Request for Class II Permissive Change

FCC ID: VG8XC042AYY

Data: 2017-3-28

1. Changed Mother board as below.

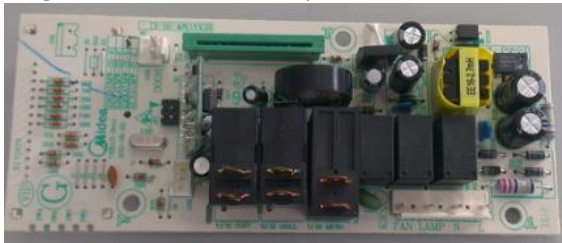
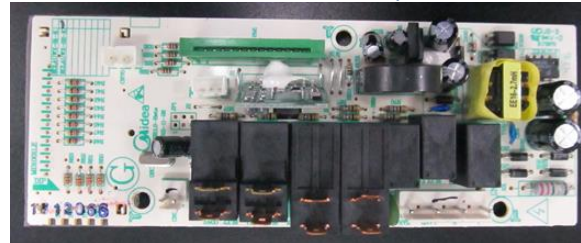
Original Mother board-top view

New Mother board –top view

New mother board is basically identical to original except for tiny PCB layout. Since new mother board is with LED lamp's output instead of original incandescent lamp's output.

2. New LED lamp instead of original incandescent lamp(see below)

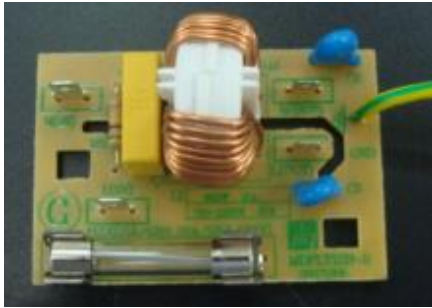
Original Incandescent lamp

New LED lamp

3. Changed power Filter board below:

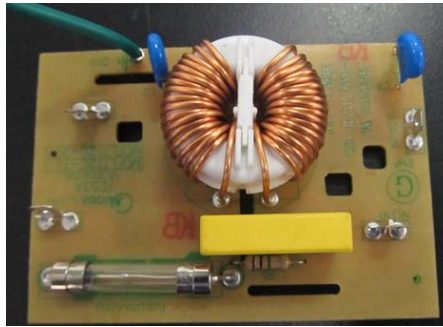
Original

New
